September 19, 2018

Urgent: Important Safety Update
AFX[®] Endovascular AAA System

This letter provides important information related to the AFX Endovascular AAA System (AFX System) which is intended for the endovascular treatment of patients with abdominal aortic aneurysms (AAA). In previous safety updates, Endologix has provided information on the rates of Type III endoleaks and suggestions for patient surveillance and treatment. This notification provides the following additional information:

Figure 4: Ensure Guidewire Is Not Caught Behind Stent Strut

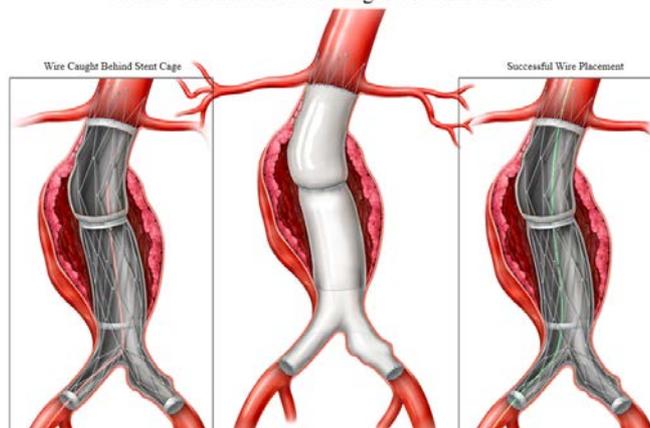
1. Refer to institutional protocols relating to anesthesia, anticoagulation and monitoring of vital signs.
2. Position patient on imaging table allowing fluoroscopic visualization from the aortic arch to the femoral bifurcations.
3. Gain luminal access through the femoral arteries.
4. Establish adequate proximal and distal vascular control of the surgically exposed femoral artery, as needed.
5. Following the manufacturer’s instructions for use, advance a flexible “J-tip” guidewire, pigtail catheter, or acceptable equivalent, into the vasculature under fluoroscopy.
 - NOTE: Proper device choice may limit the likelihood of tracking behind a stent strut. Reference **Figure 4**.

Figure 5: Use of a Balloon to Confirm Correct Placement of Guidewire

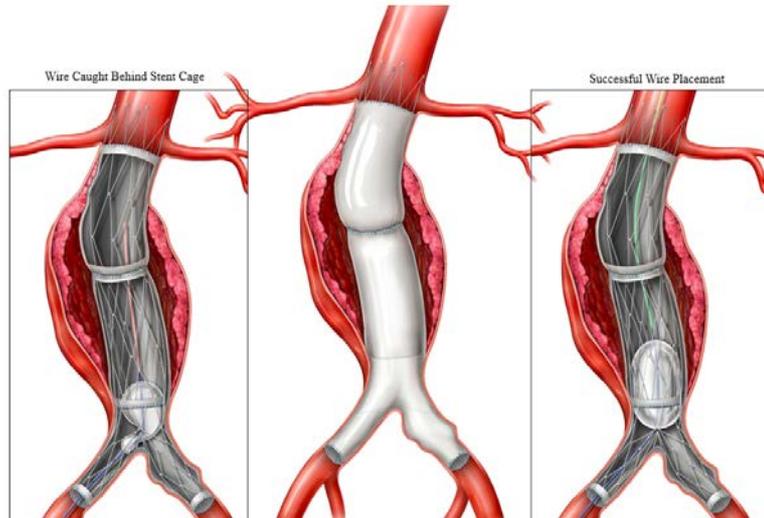
6. Once the flexible “J-tip” guidewire or pigtail catheter reaches above the existing AFX device, slowly advance an occlusion balloon or PTA balloon over the wire and under fluoroscopy. Slowly inflate, per the manufacturer’s instructions, until the balloon has been fully shaped or formed. It is recommended to use a 12mm diameter PTA balloon or an occlusion balloon that is partially inflated to ensure devices are not behind a stent strut.
 - Advance and retract the balloon catheter up and down the entire length of the existing AFX device to ensure there is proper luminal wire access.
 - NOTE: Balloon kinking during inflation or enlargement of a section of the stent cage may be a signal of a potential wire placed behind a stent strut. Reference **Figure 5**.
